# Service Bulletin

Bulletin No. 2015-65 OEM No. 2015-64
Circulate to:	Sales Manager	Accounting	Service Manager	Technician	Parts Manager

# Official Recall Notification U.S. Federal Boat Safety Act - Mercury Diesel 2.0L Power Steering Oil Cooler Replacement

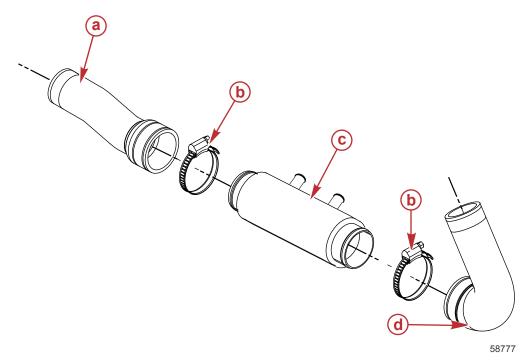
It is possible for components of the steering system to make contact with the oil cooler on the engines listed above. These engines were originally manufactured with an octagonal oil cooler. This octagonal oil cooler needs to be removed and replaced with a round (cylindrical) oil cooler in order to prevent contact from the steering system components. Some of the octagonal oil coolers have already been replaced with round ones by Mercury, making additional replacement unnecessary. If unaddressed the interference between the octagonal oil cooler and the steering system could lead to steering difficulties and/or water entering the vessel.

If cooler is round, no further action is required. If cooler is octagonal, proceed with replacement described following.

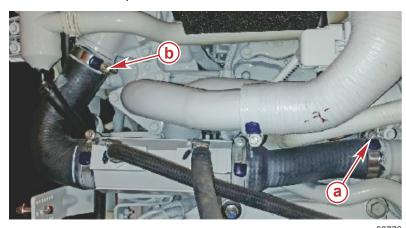
1. Loosen the hose clamp on the hose from the cooler outlet to the heat exchanger.

- a Cooler outlet hose to heat exchanger inlet
- **b** Charge air cooler outlet to the cooler inlet hose

2. Loosen the hose clamp on the charge air cooler outlet to the cooler inlet hose.

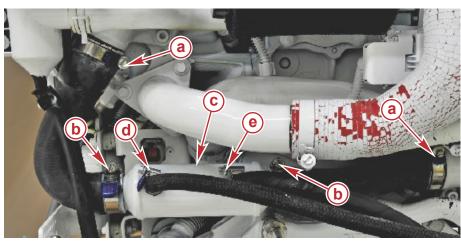
6. Install the oil hoses on the respective end of the round oil cooler. Perform this for each of the two oil hoses. Use the clamps removed earlier; tighten the clamps to the specified torque. Loosely install the assembly including the oil cooler, water hoses, and clamps.

- a Clamps used from old cooler
- **b** Clamps (new) supplied with hose kit
- c Round oil cooler
- Return oil line to the fluid reservoir, clamp used from old cooler
- Oil line from the steering cylinder, clamp used from old cooler

58796

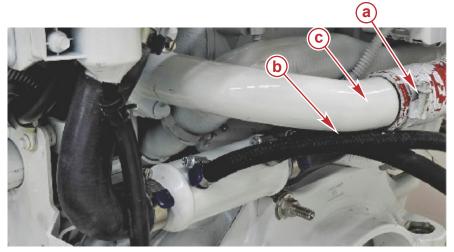
7. Orient the cooler as shown with the oil hoses nearly touching the pipe. Rotate the hose clamp on the air supply pipe as shown, tighten securely.

- a Rotate clamp as shown
- **b** Oil hoses nearly touching pipe
- c Air supply pipe
